Attachment 1
NRC3-12-0003

Table of RAI Response Dates
(5 pages)

Response to RAI Letter No. 70
(eRAI Tracking No. 6217)

RAI Question No. 02.05.02-17

Figure 3.7.1-230: Comparison with Envelopes of the Response Spectra of Computed Horizontal Component Surface Motions for Full Soil Column Profiles Using the RB/FB Enhanced SCOR FIRS Input Motions with the Horizontal PBSRS.

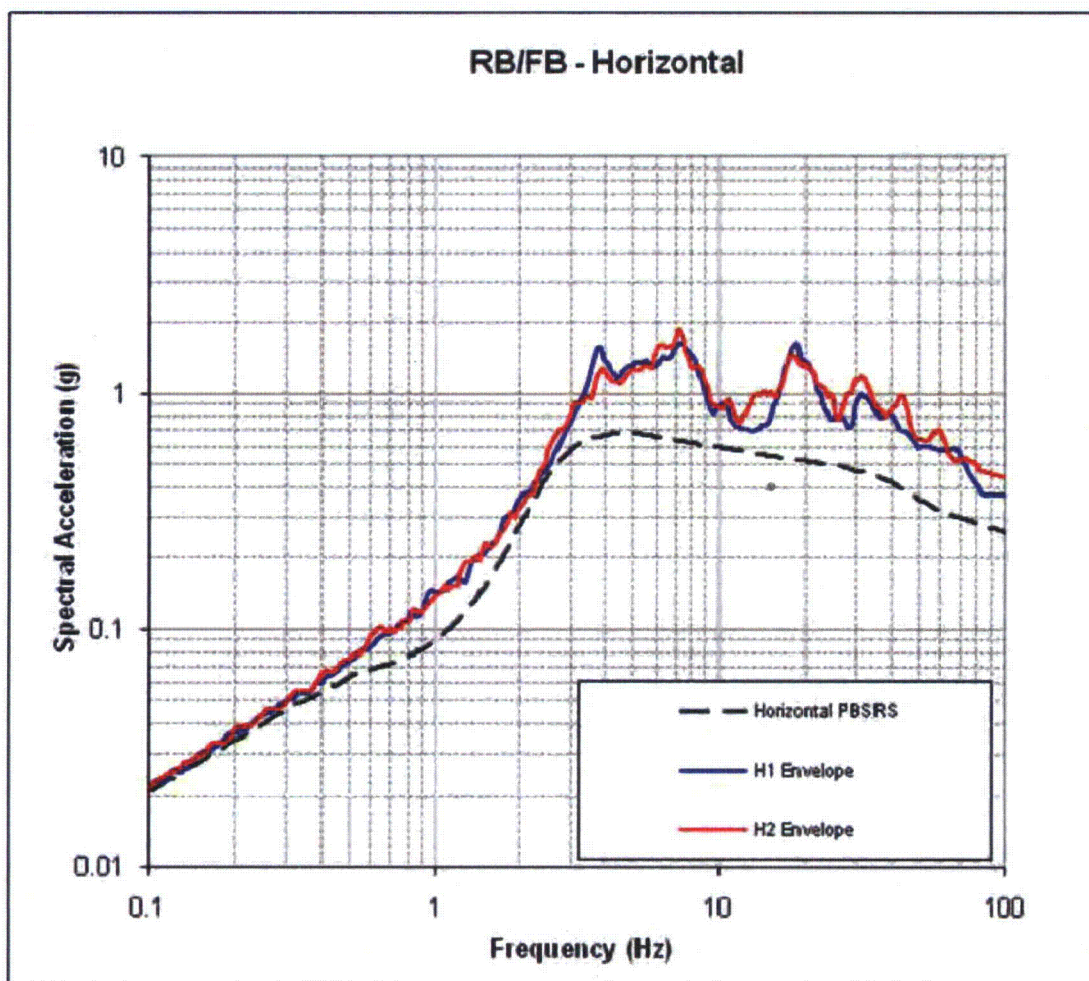
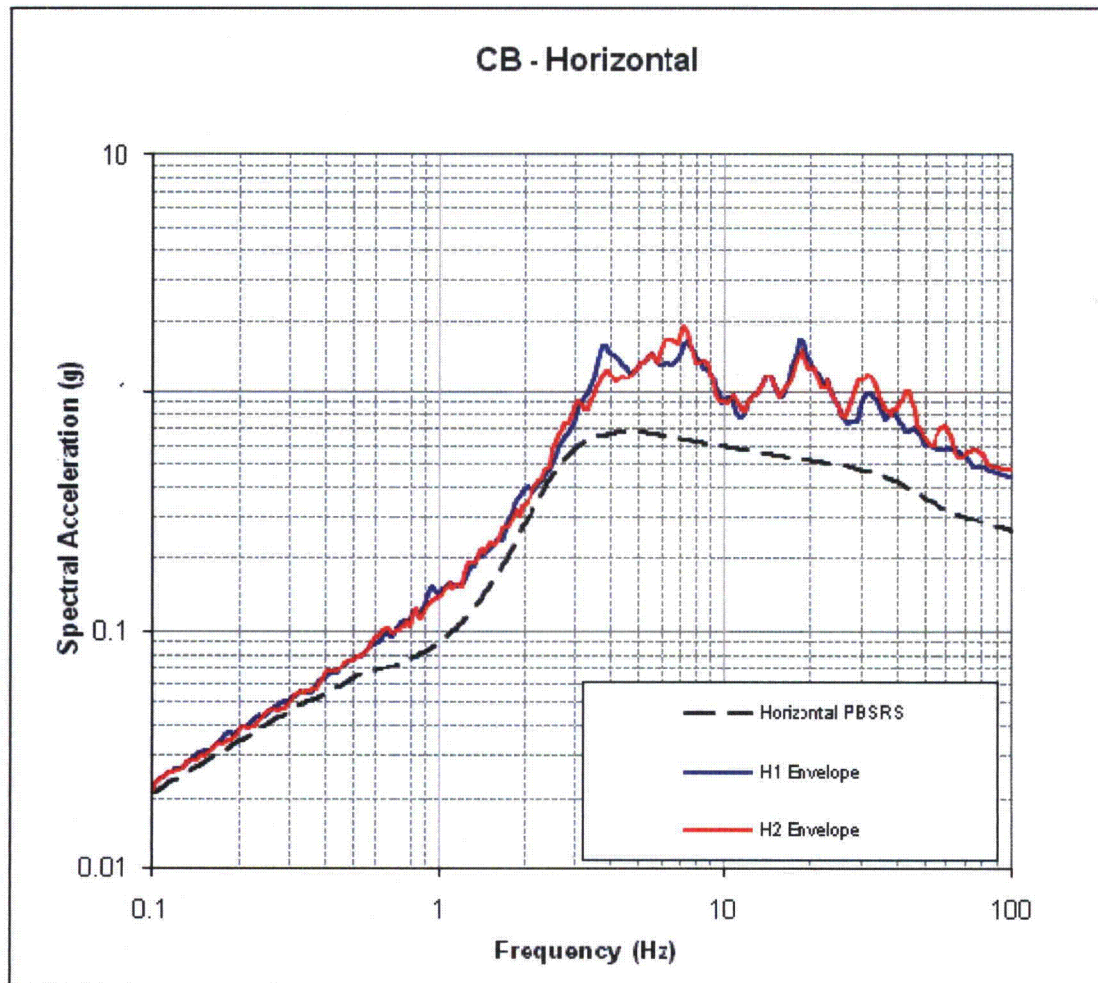
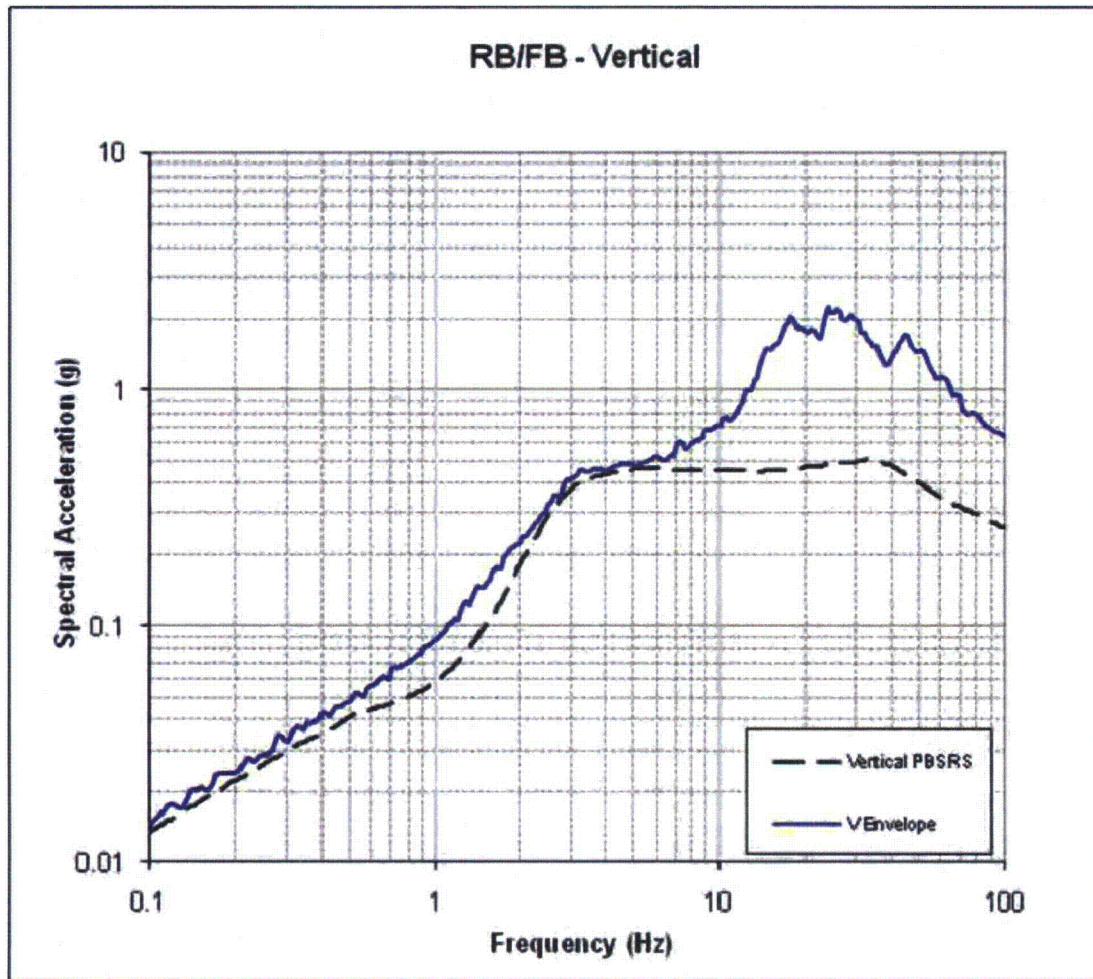
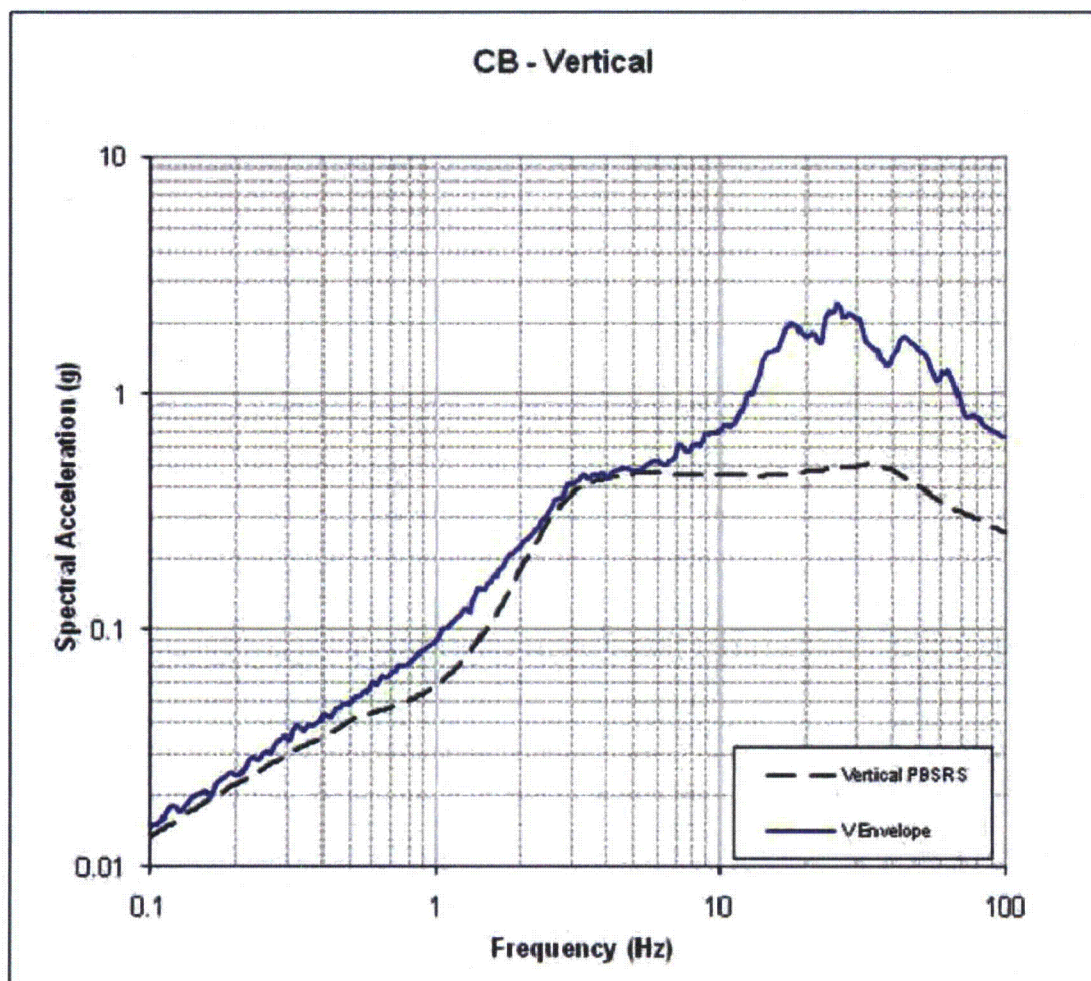
Based on the above discussion, the staff needs additional technical basis for using two components of ground motion with correlation coefficient of approximately 0.30. If Regulatory Position C.2.2(2) of RG 1.92 is used for determining the total site-specific seismic demand for the SSCs, the applicant is requested to provide a comparison with the seismic demand as determined from the use of Regulatory Position C.2.2(1), and demonstrate that the current site-specific seismic demand as specified in EF3 FSAR is not under predicted.

finished ground level grade using the full soil column LB, BE, and UB subsurface profiles, and that the resulting envelope of the three surface spectra from the time histories should envelop the PBSRS at the finished ground level grade. This comparison was made by matching the seed time history using the methods discussed in this section to the SCOR FIRS presented in Subsection 3.7.1.1.4.5. The matched time histories compatible with the SCOR FIRS were then input into the three deterministic soil column profiles (LB, BE, and UB) for the full soil column, shown on Figure 3.7.1-225, and convolved to the PBSRS level at finished ground level grade with SHAKE analyses. Figure 3.7.1-240 to Figure 3.7.1-251 show the comparison of the PBSRS at the finished ground level grade with the surface response spectra obtained from SHAKE analyses using the LB, BE, and UB full soil column profiles and the matched time histories compatible with the RB/FB and CB SCOR FIRS. The envelope of the three response spectra at the ground surface exceeds the PBSRS at the finished ground level grade for each component of motion, satisfying the requirement specified in Interim Staff Guidance DC/COL-ISG-017 and the NEI developed white paper (Reference 3.7.1-206).
